2-28 MONTAGUE STREET, 80 MUNRO STREET, JOHNSON STREET, SOUTH MELBOURNE

PREPARED BY: SIMON GUTTERIDGE, PLANNING TEAM LEADER FISHERMANS BEND

- 1.1 To provide a Council position for the Fishermans Bend Standing Advisory Committee on an application to the Minister for Planning to prepare, adopt and approve an Amendment to the Planning Scheme under Section 20(4) of the Planning and Environment Act for 2-28 Montague Street and 80 Munro Street, South Melbourne.

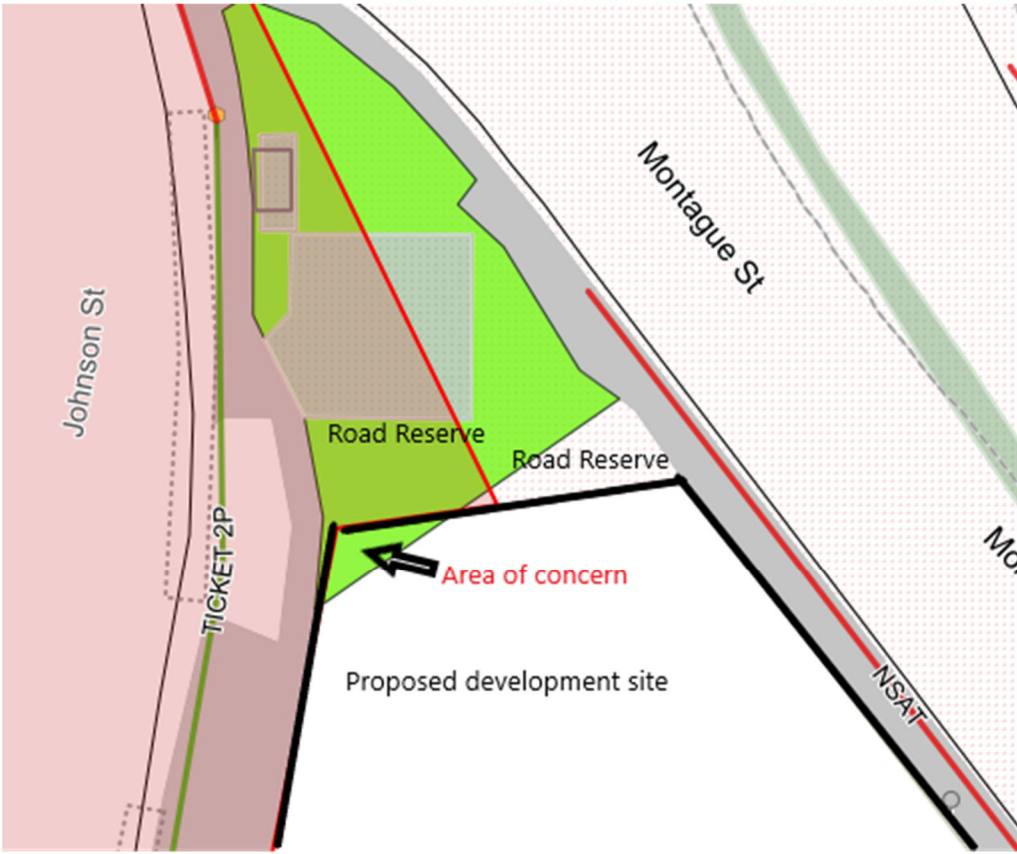
<p>are entirely undercover. This occurs between Towers 1 and 2 and between Towers 2 and 3. The use of a full canopy over laneways on plantings is not supported. Laneways should have access to the sky allowing plants to have access to natural light and rainwater.</p> <p>f) Proposed canopy impacts existing planting and precludes future planting</p> <p>Clause 21.05-3 point 1.3 encourages the provision of weather protection in retail and commercial areas. The proposed development does provide weather protect through canopies, however the proposed canopy appears to cut off existing trees on Munro Street.</p> <p>Clause 21.05-3 point 3.6 notes that tree planting should be retained and increased. Notes on plan view (SD01) do not indicate the status of existing trees; elevations on SD04 do not show the existing trees. If these trees are to be removed, the applicant should provide mitigation of this loss at street level. If the trees remain, the applicant should address impacts that the proposed building canopy will have on existing trees, as the canopy appears to cut trees off around five metres.</p> <p>Given that Munro street is generally south facing and will be in shadow for much of the day, the proposed canopy width could be reduced to allow the existing trees to remain.</p> <p>g) The status of existing trees on Johnson Street is unclear</p> <p>Similarly, Clause 21.05-3 applies to the status of existing trees on Johnson Street. These trees are not addressed by the plan view (SD01) with notes or with a legend and are not indicated on elevations (SD04). The street trees on Johnson Street should remain in place and be sufficiently protected to prevent damage during construction. These trees will be a critical part of the planned linear park on Johnson Street as indicated in the Fishermans Bend Framework (page 69).</p> <p>h) The development does not address the public realm on Montague Street</p> <p>Clause 22.15-4.7 encourages developments to provide landscaping in all areas of open space. Proposal does not address the surrounding streets or public realm except within their own property line. However, the development does provide large canopies which preclude existing or proposed street trees. For example, Montague Street is proposed to have a large overhanging canopy but will also experience full sun for most of the day as it faces north. Street trees may reduce the impacts that full sun will have on the ground floor uses and soften the impact of Montague Street as an arterial road.</p> <p>i) Use the landscape within the public space to contribute to the local identity or celebrate heritage, culture or Aboriginal cultural heritage</p> <p>Clause 22.15-4.7 landscape areas should contribute to the creation of a sense of place and identity and the preferred character sought for the precinct and interpret and celebrate heritage and culture, including Aboriginal cultural heritage. The landscape plan does not address the local context in any way. The applicant should have consideration to the local context within the design of the public realm.</p> <p>j) Turfstone is not an accessible footpath material</p> <p>Clause 58.03-2 states that a developer should ensure that communal open space be accessible, useable and capable of efficient management. Clause 21.05-4 asks that the planning and maintenance of physical infrastructure is accessible to people of all abilities.</p>

<p>The use of Turfstone as a footpath material will exclude a number of groups from accessing a number of areas including women wearing heels, people using mobility devices or those with mobility impairments and people pushing prams. Turfstone is used extensively across the sites including at the bottom of stairs, under bicycle stands, and within a planted plaza space. The developer should select another material that allows for permeability and equal access to all users.</p> <p>k) Ramps to retail units require impaired persons to take circuitous routes While retail spaces may be accessible, they are not inclusive. Anyone using a mobility device, pushing a pram, or with a physical impairment will be required to travel +65 metres on Johnson Street to access a ramp and then turn back to access retail units. Retail on Johnson Street should at a minimum be accessible from the corner of Johnson and Monroe Streets and within the plaza.</p> <p>l) Please provide further information on the external appearance of the car park air ventilation in the plaza and how the impacts will be mitigated</p> <p>2) <u>Landscape Plan – Level 1 (Façade Planters)</u></p> <p>a) Please provide further information on the purpose of the façade planters Do the façade planters mitigate the impacts of wind? What benefit do they have for residents? Are they impacting on access to daylight?</p> <p>3) <u>Landscape Plan – Level 5 (Top of Podium)</u></p> <p>a) Tower 1 does not have access to public open space Clause 58.03-2 Standard D7 requires that developments with 40 or more dwellings should provide a minimum area of communal open space of 2.5 square metres per dwelling or 250 square metres, whichever is lesser. Those residing in Tower 1 do not have access to communal open space, other than at ground level in the publicly accessible plaza and footpaths. How will this lack of access be addressed?</p> <p>b) Communal open space should be located on the north side of a building Clause 58.03-3 Standard D8 requires that outdoor open space be located on the north side of the building. At least 50 per cent or 125 square metres, whichever is the lesser, of the primary communal outdoor open space should receive a minimum of two hours of sunlight between 9am and 3pm on 21 June. A significant portion of Tower 3’s outdoor space at podium level will be in shadow for almost all of the day between 9am and 3pm on June 21, with no access to the landscaping on the north side of the building. City Design recommends that the applicant redesigns Tower 3 to provide communal open space located on the north side of the podium. This redesign would also provide passive surveillance of the plaza achieving clause 58.03-2.</p> <p>c) Level 5 landscape plan should reinforce the activation of the central plaza and pedestrian routes by creating an edge condition that allows overlooking of the plaza Clause 58.03-2 Standard D7 states that communal open space should be located to provide passive surveillance opportunities. All Level 5 landscapes propose significant planted buffers preventing pedestrian access to the edge. Level 5 landscape plans should create edge conditions that allow overlooking of the central plaza and pedestrian footpaths to support activation.</p> <p>d) Level 5 landscape plan should support a range of activities</p>
